IMPORTANT SAFETY RECALL

NHTSA RECALL NO. 20E091

We are writing to inform you that Öhlins USA, Inc. is conducting a voluntary safety recall of certain Öhlins front struts intended for aftermarket installation on certain Porsche models. These front struts were shipped to customers as part of the suspension kits identified below. Each kit contained two of the affected front struts (Part No. POS 5N20) along with two rear struts, springs, and associated hardware. (These other components are not affected by this recall.) Our records indicate that some of these kits were shipped to you. Please review this letter carefully.

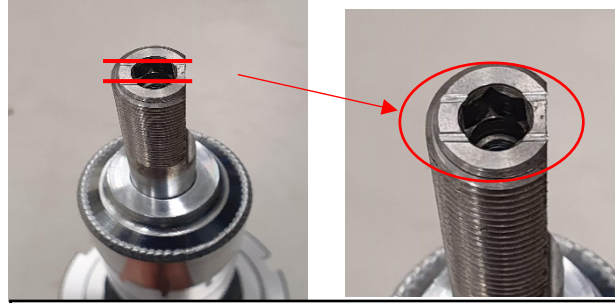
Due to a design compatibility issue related to the interface between the vehicle's top mount and the strut, the pin of the strut may experience excessive stress during maximum steering, which can lead to fatigue and, potentially, breakage of the pin. If the pin fails, it will result in the separation of the strut from the vehicle and compromise front-wheel control, increasing the risk of a vehicle crash.

Replacement product is identified by two parallel marks on top of the pin, visible from the engine compartment in the installed position.

- (1) Inspect the customer's front struts to confirm that they are covered by this recall. Only POS 5N20 struts without the markings should be replaced;
- (2) If the product is covered, arrange to have the strut replaced with a new Öhlins front strut, Part No. POS 5N20 or POS 5N21, and the new OE / top mount interface solution, all included in a recall kit that will be provided by Öhlins, at no cost to the customer;
- (3) Submit a claim under the Öhlins warranty claims process and according to instructions included in the recall kit.
